## CITY OF ST. AUGUSTINE CORRIDOR REVIEW COMMITTEE

### A G E N D A

THURSDAY, NOVEMBER 6, 2025 - 2:00 PM

WEST KING TOWNHOMES  
**King Street Corridor Review  
Committee Presentation**

SOUTH ELEVATION  
1/8"=1'-0"

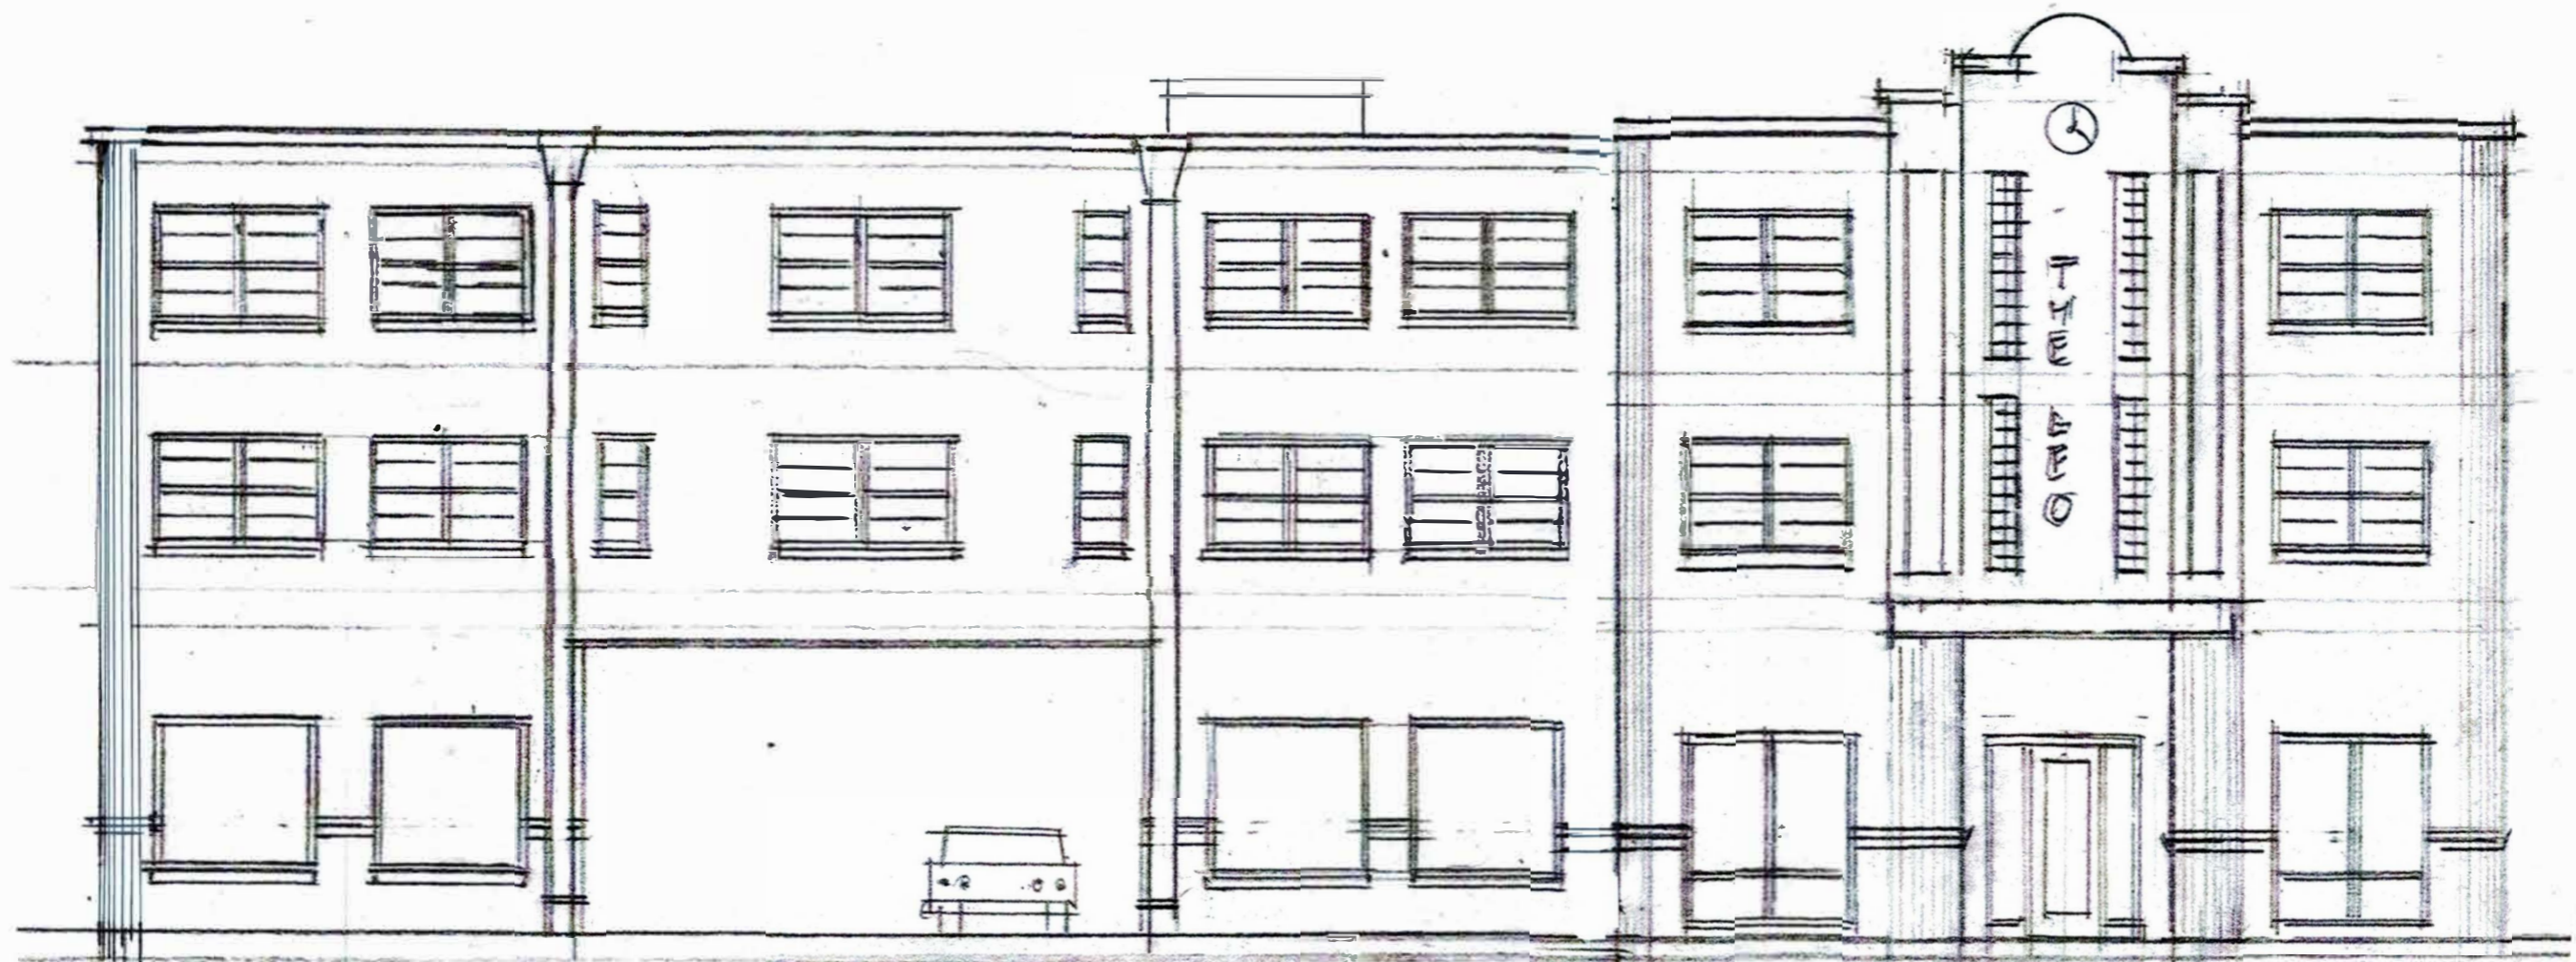
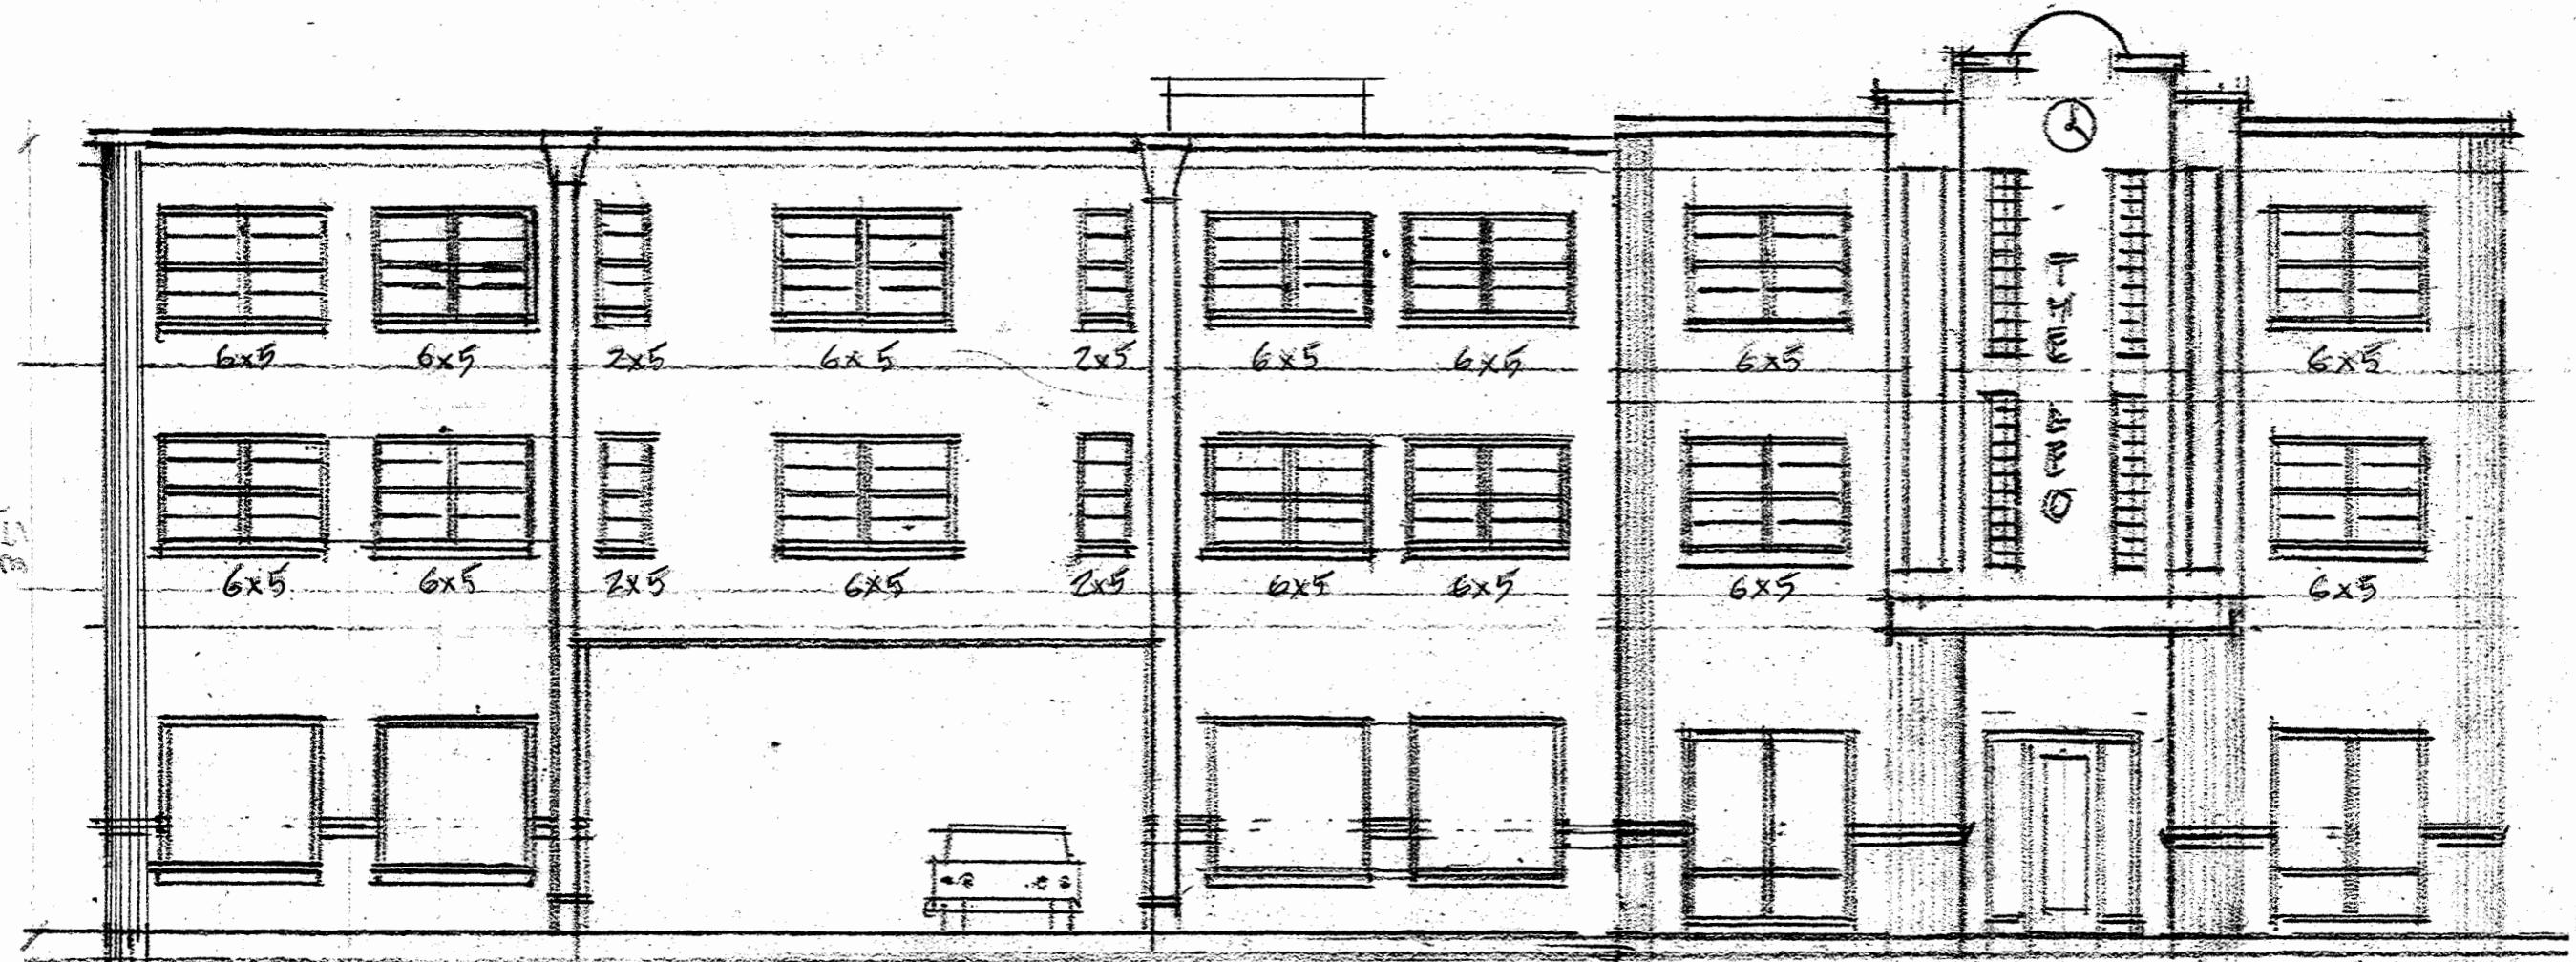
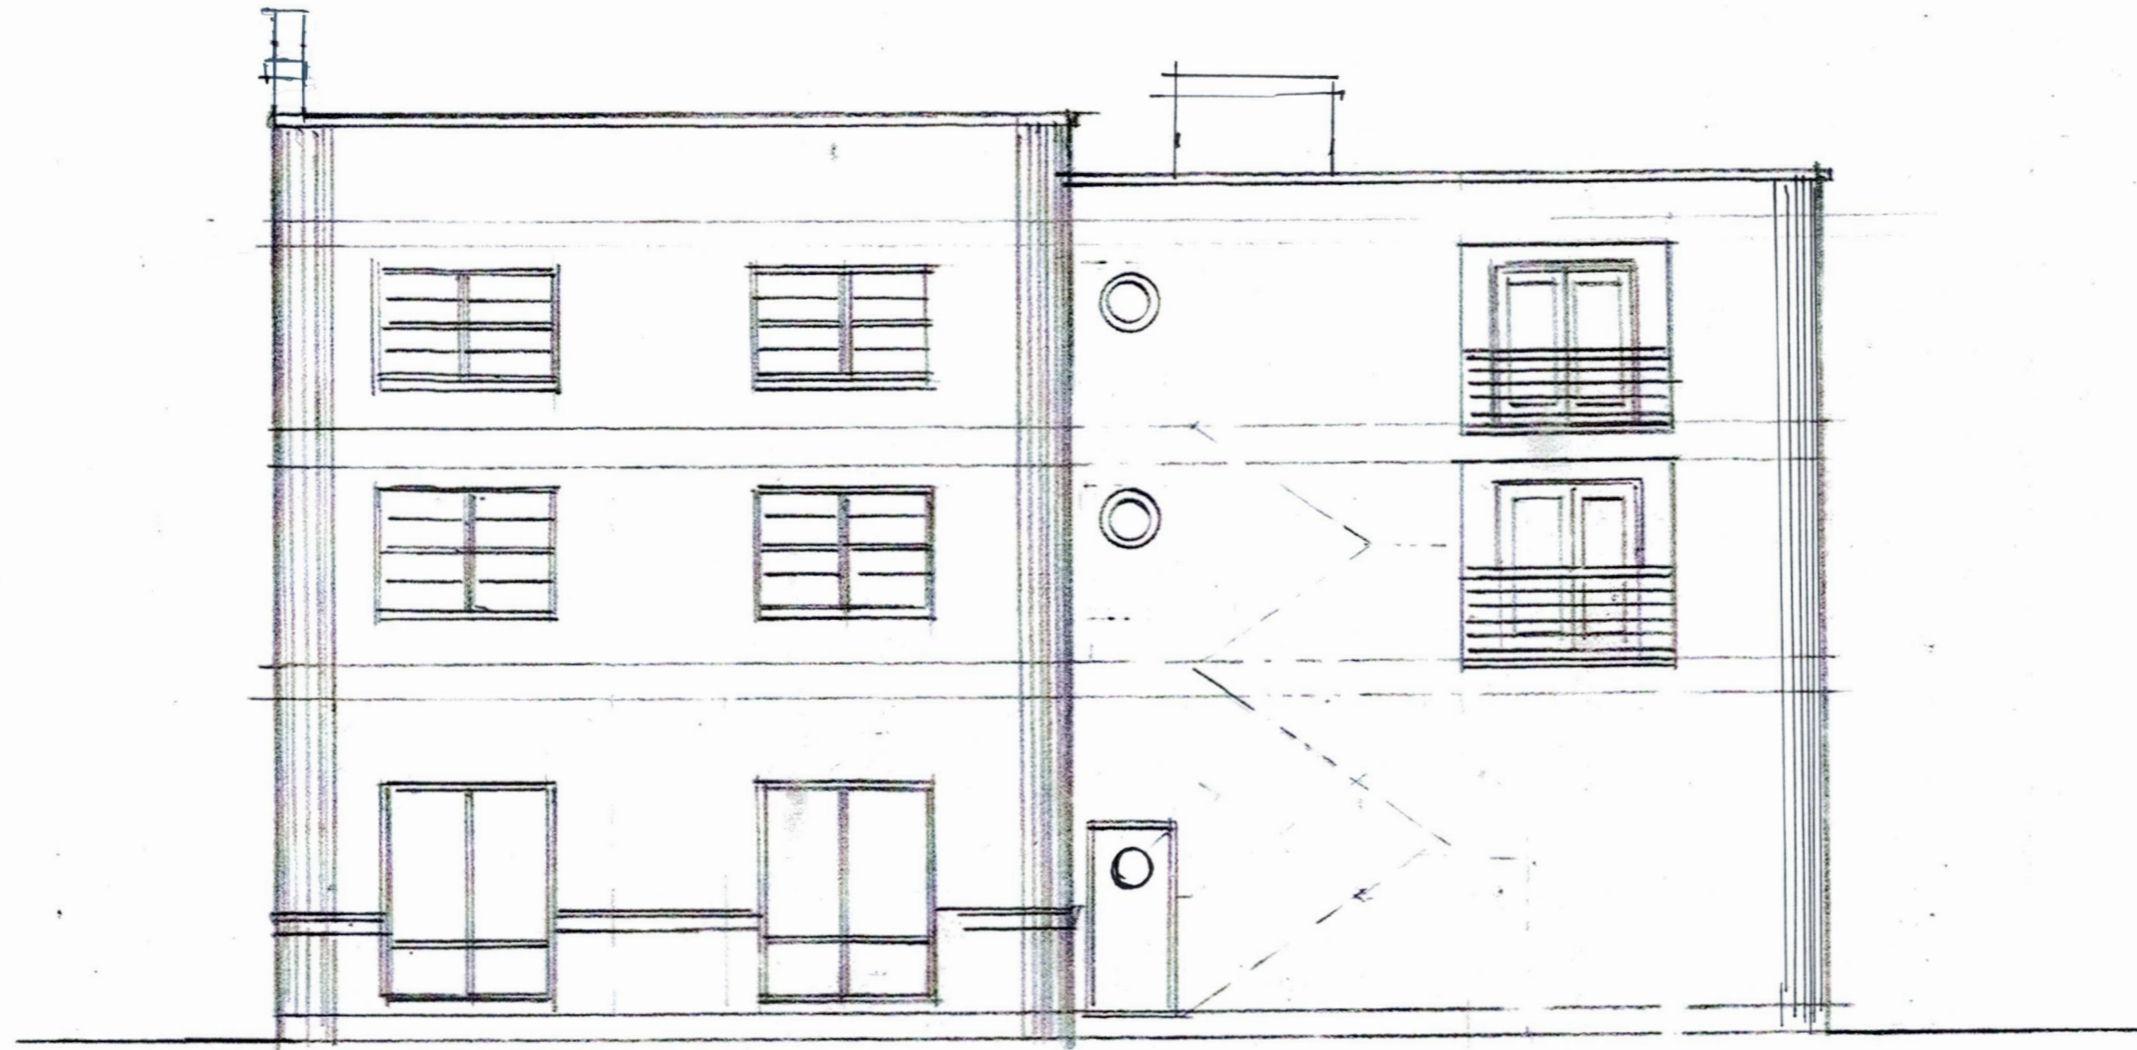
7. There are no color requirements in the W. King portion of the corridor. No specific colors were proposed with this application.
8. The DSEC states that openings, including porch openings, are counted in glazing calculations. Excluding the 24'x13.5' driveway opening, ground floor fenestration along W. King Street meets DSEC glazing requirements with no need for modification approval. If the driveway opening is included, the proposed glazing can be approved by the CRC as a modification to the standards. Window and glass door types are appropriate for the architectural style and the streetscape; however the two 6'x8' windows flanking the entry door do not appear to have an appropriate height bulkhead/kickplate which the standards state must be a minimum of 12".
